# Product Change Notification

**Change Notification #:** 112295 - 00  
**Change Title:** Intel® Server System P4304BTLFCNR and P4304BTLSHCNR  
PCN 112295-00, Product Design, Label, Update Cables and Labels  
**Date of Publication:** June 06, 2013

Intel will implement the following changes on the Intel® Server System P4304BTLFCNR and P4304BTLSHCNR.

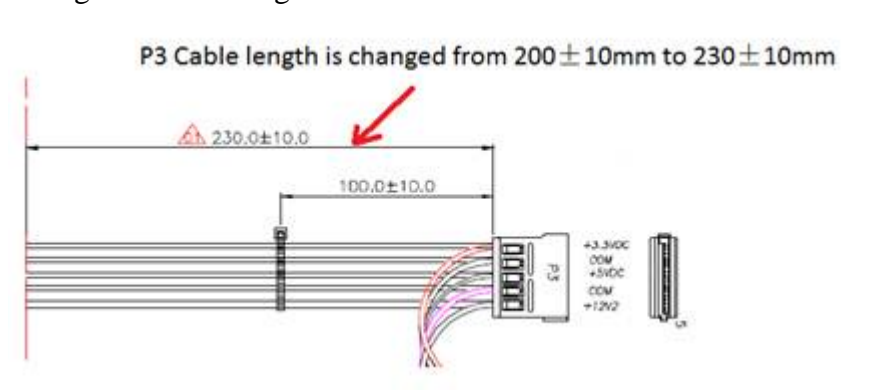
1. Change the cable length of P1 from 170mm to 290mm

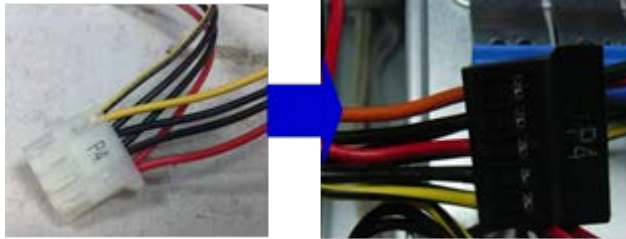
2. Change the cable length of P3 from 200mm to 230mm.
